*LEOMINSTER*  
*LOCAL PROTECTION PROJECT*

**MONOOSNOC BROOK**  
**LEOMINSTER, MASSACHUSETTS**

*FINAL*  
*ENVIRONMENTAL STATEMENT*  
*& 404 EVALUATION*

JANUARY 1980

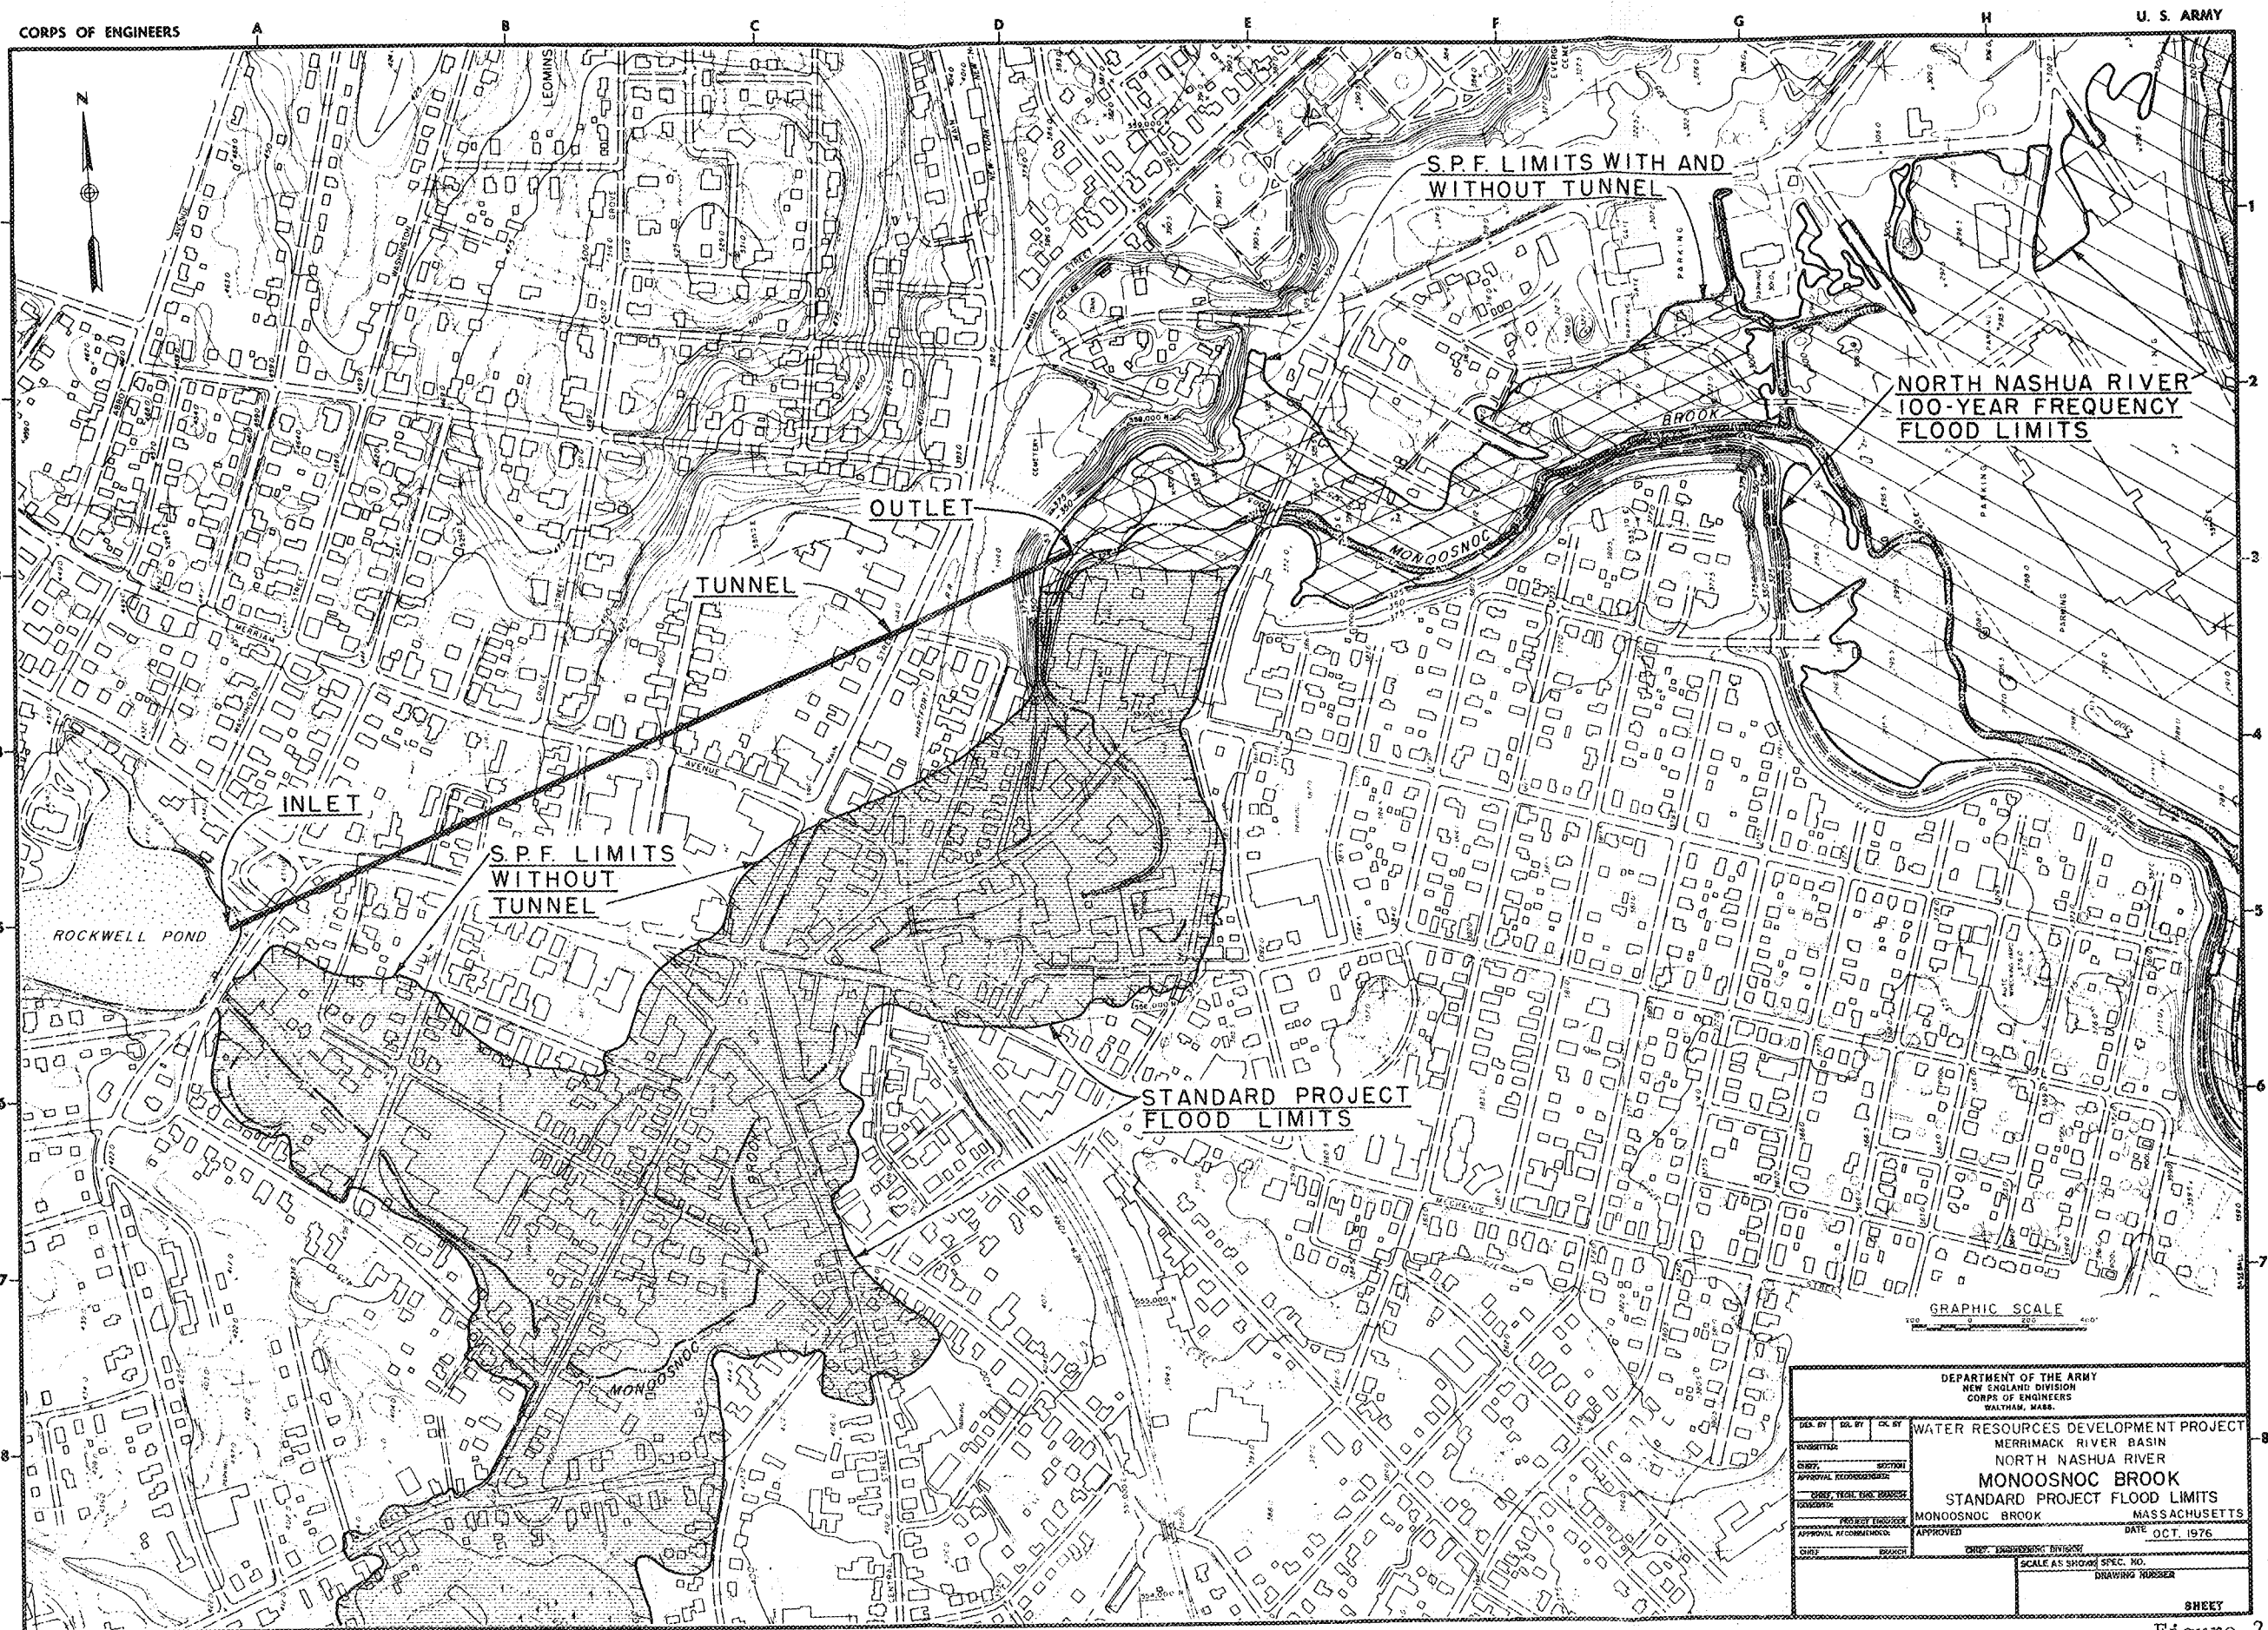
Comment: "2:07 - Geology is generally described as bedrock covered by sand. Figure 3 shows "assumed bedrock" which to us indicated somewhat limited core or bore tests were taken to locate this rock. To undertake such a large elaborate project based on assumptions seems somewhat curious. No data on core samples, locations, etc., were noted in the Statement."

Comment: In Figure 3, the geology appears not to have been explored thoroughly: we find the legend "assumed bedrock" which can only mean that no one is completely certain of the underlying rock structure. (If this is true, how can accurate cost estimates for the boring of the pipeline be made)?

Comment: "'Assumed bedrock" is mentioned in Figure 3. To what extent has this bedrock layer been investigated? How precisely can cost estimates be made before a thorough examination of the presumed bedrock layer is made?"

2:07- Geology is generally described as bedrock covered  
by sand. Figure 3 shows "assumed bedrock" which to us  
indicated somewhat limited core or bore tests were taken  
to locate this rock. To undertake such a large elaborate  
project based on assumptions seems somewhat curious. No  
data on core samples, locations, etc. were noted in the  
Statement.

1) In Figure 3, the geology appears not to have been explored thoroughly: we find the legend "assumed bedrock" which can only mean that no one is completely certain of the underlying rock structure. (If this is true, how can accurate cost estimates for the boring of the pipeline be made?)

"Assumed bedrock" is mentioned in Figure 3. To what extent has this bedrock layer been investigated? How precisely can cost estimates be made before a thorough examination of the presumed bedrock layer is made?

Response: Two borings and seismic investigations were conducted. The borings were taken at the intake and the discharge structures. The seismic investigations were also near the discharge structure. Bedrock is very common in this area and our sampling confirmed this point. Also, the assumed bedrock designation only means that the Corps does not have complete information on the area; however, sufficient information exists for a reasonable prediction of the bedrock in the area. If necessary, further subsurface explorations could be made during Phase 2 studies or prior to preparation of plans and specifications.
